## RFQ Questions and Responses 19-20-01 Electrical Engineer

### Building 700 Transformer Replacement

## RFQ Questions and Responses 19-20-01 Electrical Engineer

### Exterior Lighting Upgrades

**PHOTOS OF EXISTING TRANSFORMER IDENTIFICATION PLATES ATTACHED BELOW**

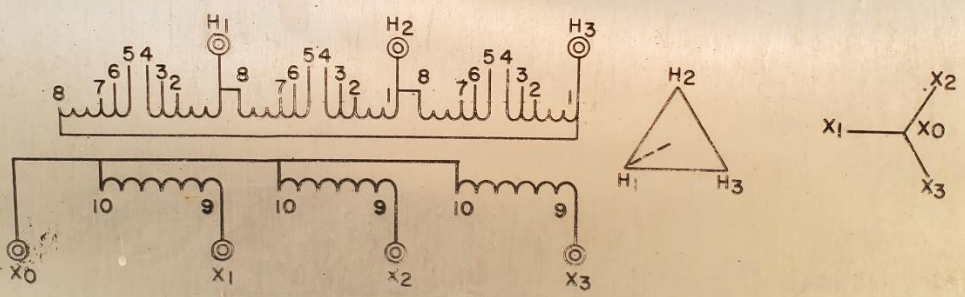
**Question:** What is the kVA capacity, primary and secondary voltage of the transformer are being replaced?

**Response:** See photos attached
